**TOWN OF SURFSIDE
PLANNING AND ZONING BOARD
AND
DESIGN REVIEW BOARD MEETING**

**JUNE 25, 2015
7:00 PM**

MEMORANDUM

To: Design Review Board
Thru: Guillermo Olmedillo, Town Manager
From: Sarah Sinatra Gould, AICP, Town Planner
CC: Linda Miller, Town Attorney
Date: June 25, 2015
Re: 9525 Carlyle Avenue

Subject Property

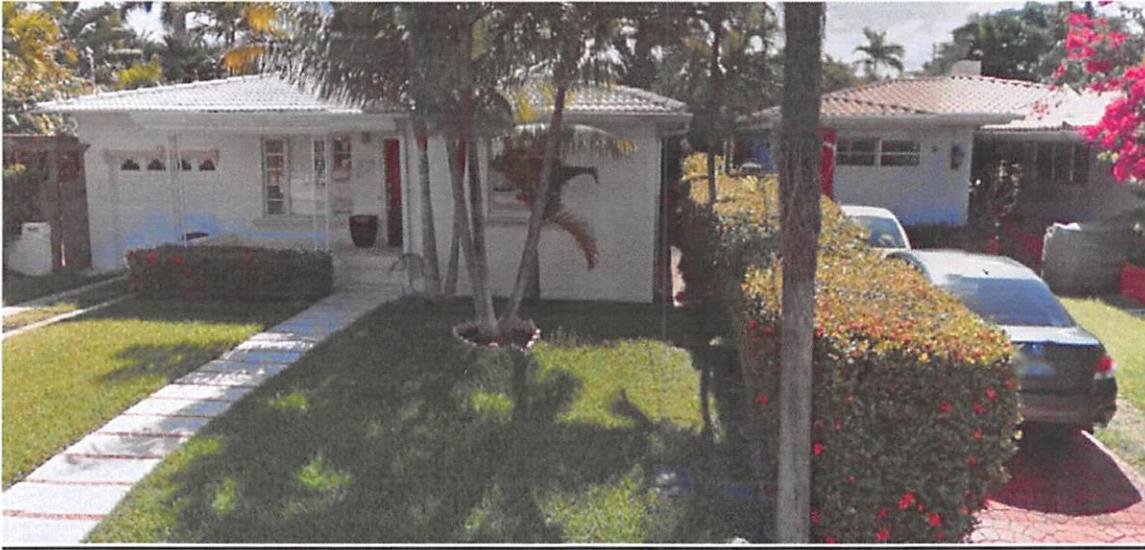
Required	Proposed
Restricted materials for roofs are pre-determined in the Town's Building Code, which restricts roofing materials to: 1. Clay tile; 2. White concrete tile; 3. Solid color cement tile which color is impregnated with the same color intensity throughout, provided said color is first approved by the planning and zoning board; and 4. Metal.	Asphalt shingle, which is not consistent with the design guidelines.

Although shingles are not a permitted roof material under the design guidelines, the zoning code permits an applicant to request approval of a different roof material by the Design Review Board if said material is approved by the Florida Building Code. Therefore, the applicant is requesting consideration by the Design Review Board to install asphalt shingles, which have been the same roof material since 1984.

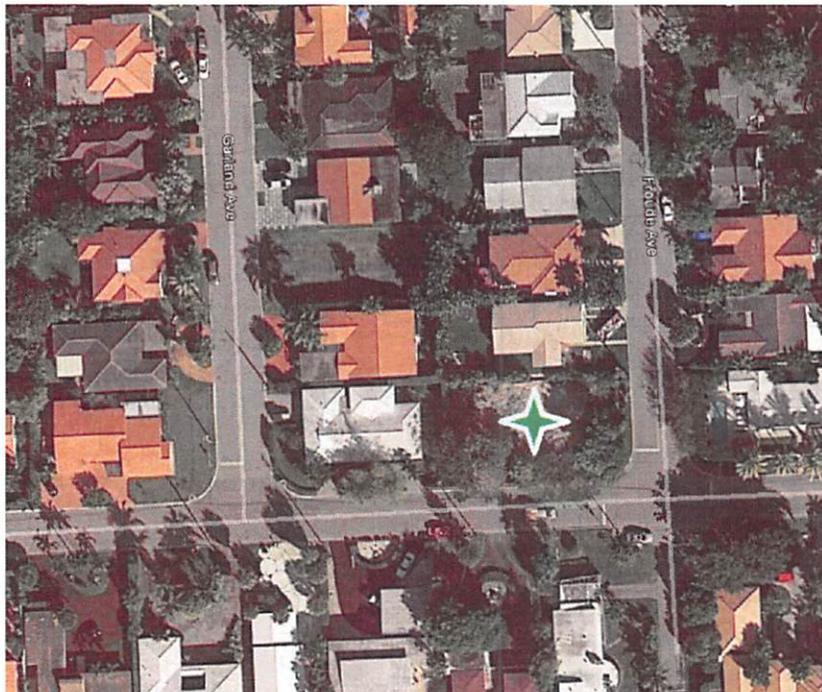
Signs	Permitted	Proposed
Area	25 square feet	16.7 square feet per façade
Approved word content	Signs may include the following: 1) Trade name of establishment 2) Logo of the establishment 3) Nature of business, services rendered or 4) Products sold on premises.	Sign consists of the trade name of the establishment
Prohibited Word Content	Signs may not include the following: 1) Any reference to price, except as provided in regards to "window sign."	No reference to price

Staff recommends approval with the condition of approval that the façade behind the sign is repaired and repainted.

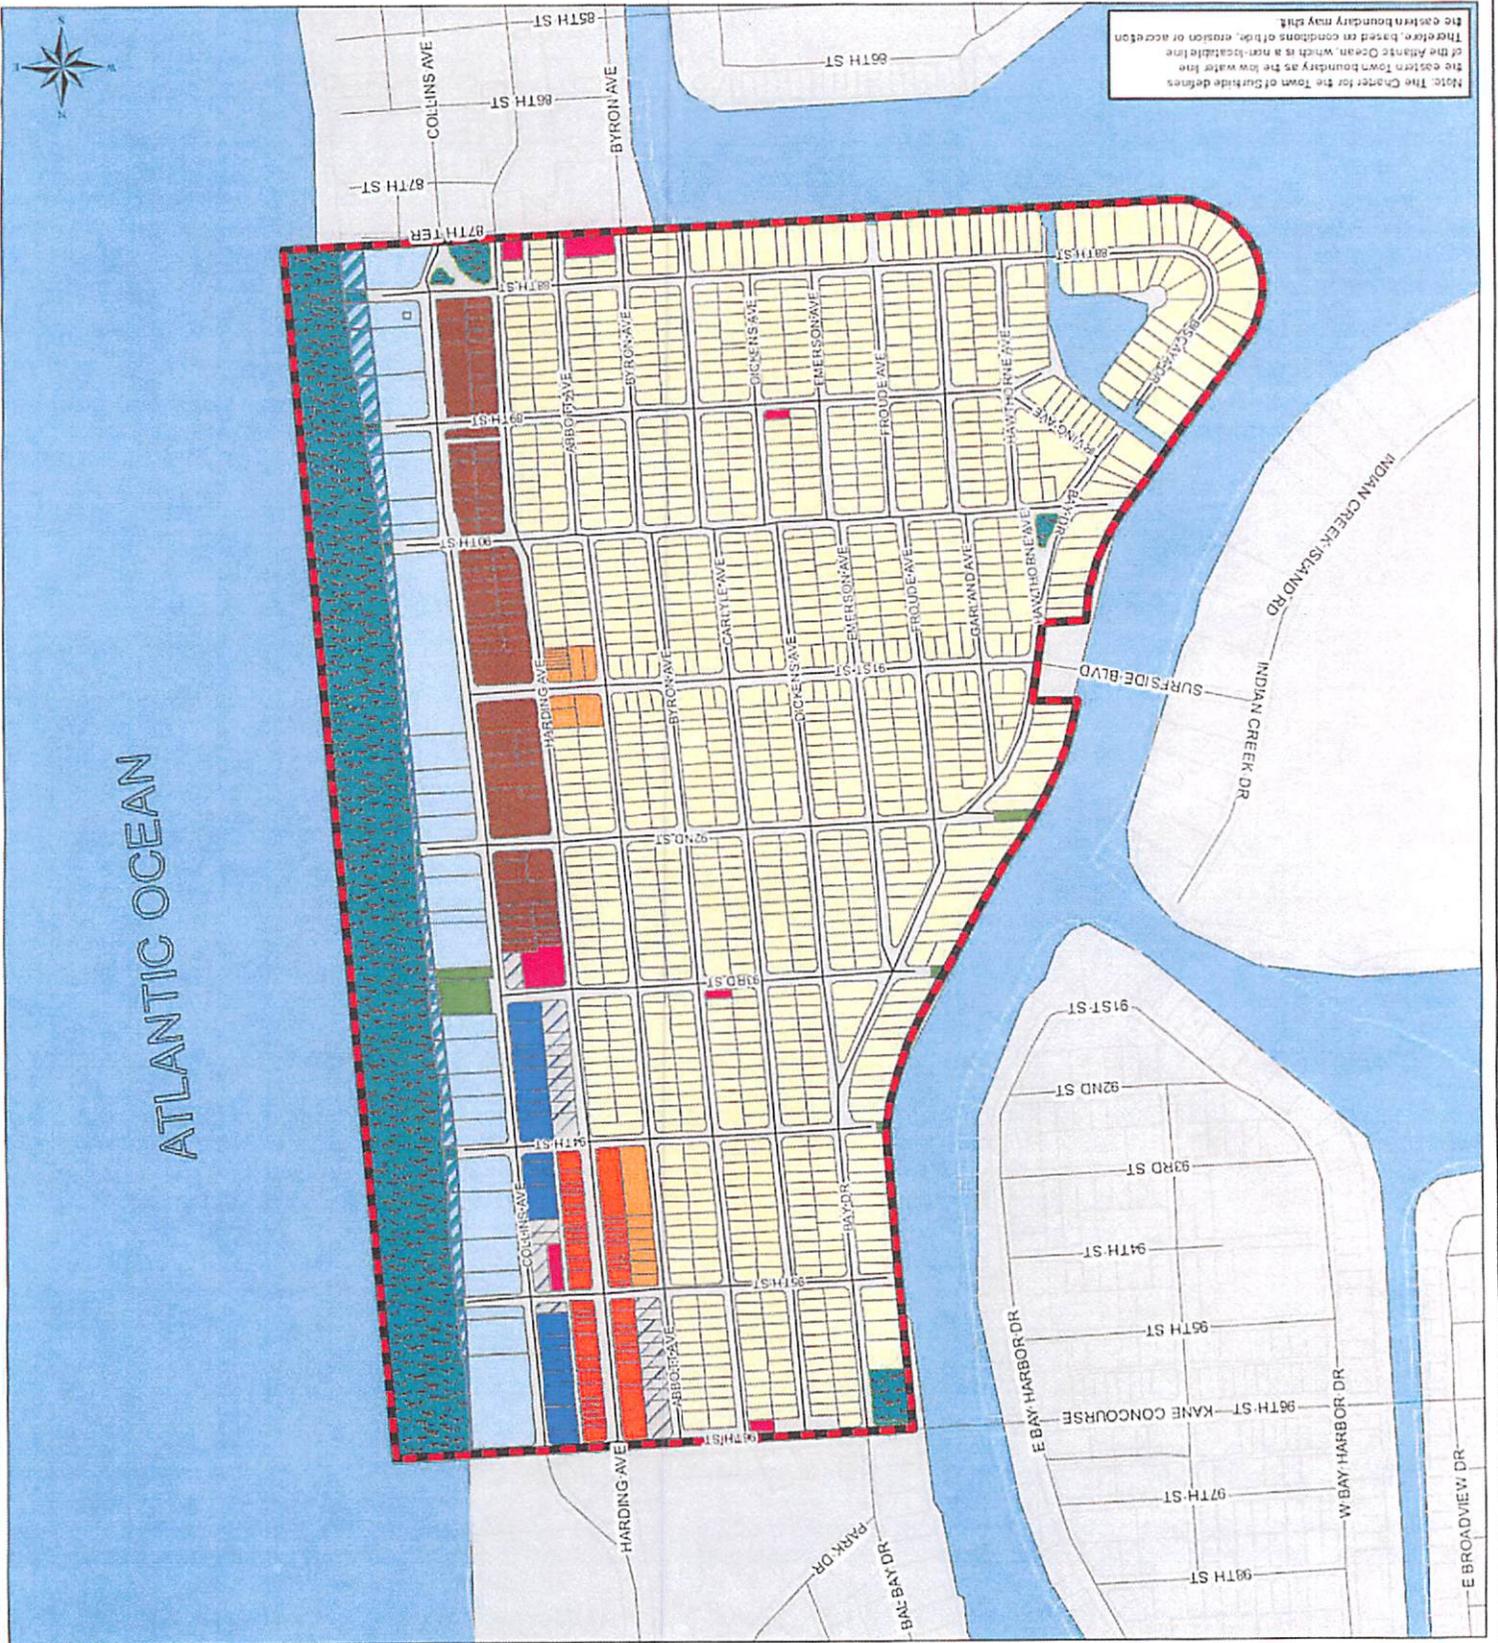
90-51.1 Continuous wall frontage shall ~~not exceed 270 feet and~~ be articulated as follows:

- (1) *H30C*: Shall not exceed 150 feet. For every 50 feet, a minimum three-foot change in wall plane.
- (2) *H40*: Shall not exceed 150 feet. For every seventy-five (75) feet, a minimum six-foot change in wall plane.
- (3) *H120*: Shall be limited to a ~~For every 100 feet, a minimum six-foot change in wall planes. The change shall be either vertical or horizontal. The maximum of 270 feet of continuous wall frontage in is limited to a~~ building platform no greater than 30 feet in height. This platform may

RECOMMENDATION: Town Commission approve the attached Ordinance amending Section 90-51.1 to provide further limitations on the maximum continuous wall frontage.
